# SAN FRANCISCO PLANNING DEPARTMENT

**MEMO**

**RE:** **Review and Comment at June 19, 2013 Hearing**  
**722-728 Montgomery Street - The Belli Building (Langerman's Building) & Genella Building (Belli Annex)**  
**Case No. 2008.1084E**

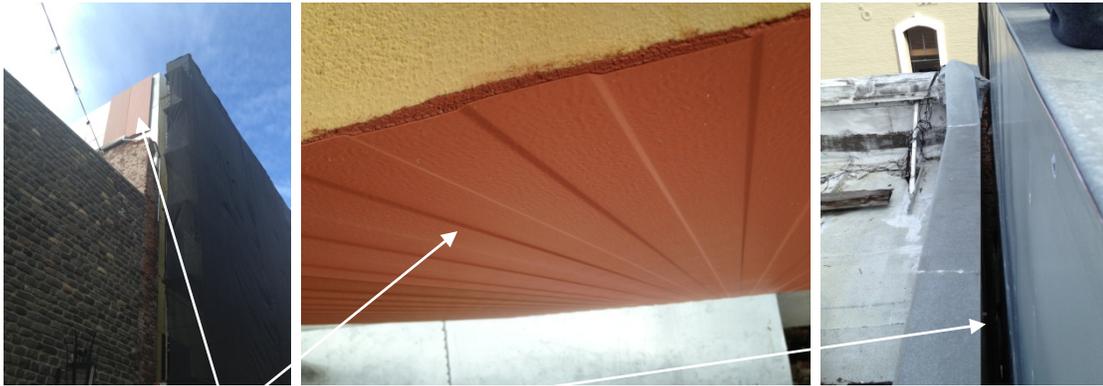
Similar to the original bricks, all the original windows on this façade have been previously removed and are no longer available for use by the current property owner. As such, new Marvin wood window are proposed to replace the original windows on the Hotaling façade. The Sponsor has indicated that the proposed windows are not custom windows but will match the windows shown on the elevations drawn by Heller Manus Architects in 2002 for a previous approval since no earlier drawings or photographs of the Hotaling Place façade were found. It is the Department’s understanding that the pattern, size and proportion of the openings are meant to reflect and reference those of the original windows along the Hotaling Place façade based on the limited documentation available. It should be noted that although the sample wood window in the picture below shows divided lights within the upper sash, the actual windows will not have divided lights.

2. The Department believes that the proposed Marvin wood windows along the Hotaling Place elevation are appropriate and meet the Secretary of Interior's Standards provided they match the original windows in size and proportion including providing ogee lugs.
